Project: MOE Nationwide FLS -
Avalon Block
Accessibility Report

Reference: 246313
Prepared for: Ministry of
Education
Revision: A
28 September 2015

Figure 2: Avalon Block FLS upgrade Option 2

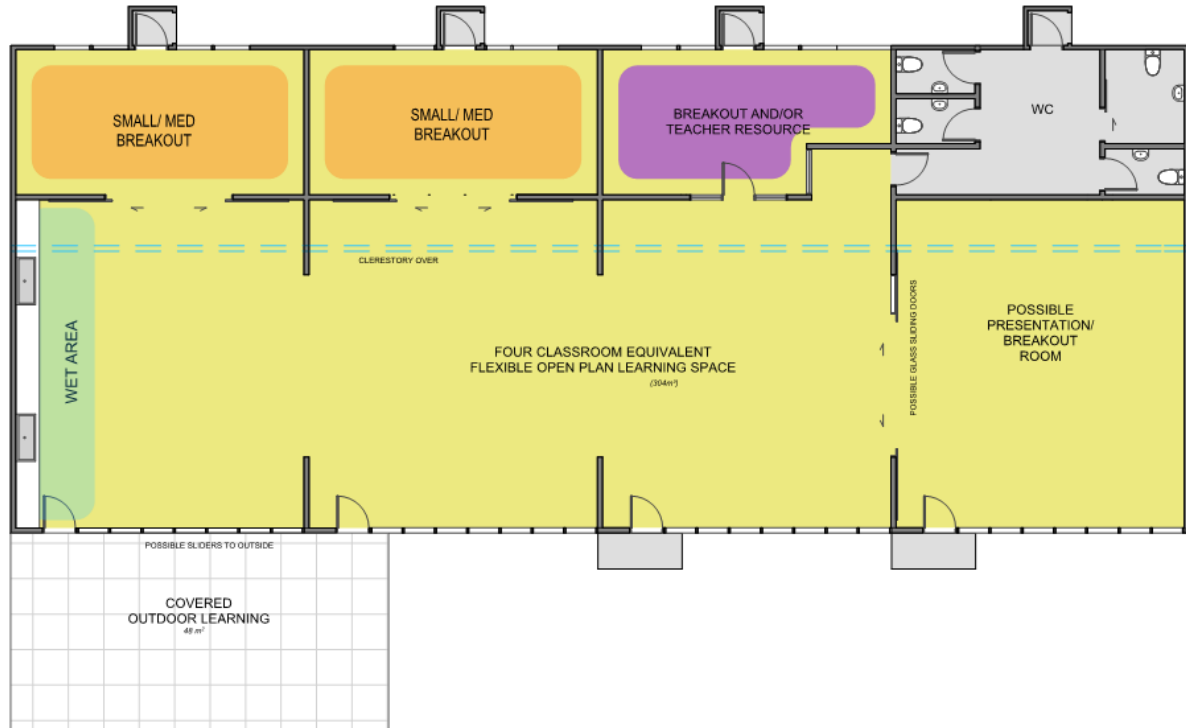
Refer to Figure 1 and Figure 2. Each classroom in Option 1 and 2 generally have steps to the entrance doors leading to the breakout rooms or bag storage. Where Avalon Block classrooms are required to be accessible, since each classroom is interconnected, it is proposed that accessible entrance to be provided at the entrance from the covered outdoor learning area.

Option 1 does not have an accessible toilet facility. This is acceptable provided that accessible hygiene facilities exist elsewhere on the school site and an accessible route between Avalon Blocks

and the facilities is available. The accessible toilet proposed in Option 2 shall comply with the requirements of NZS 4121 in Table 5.
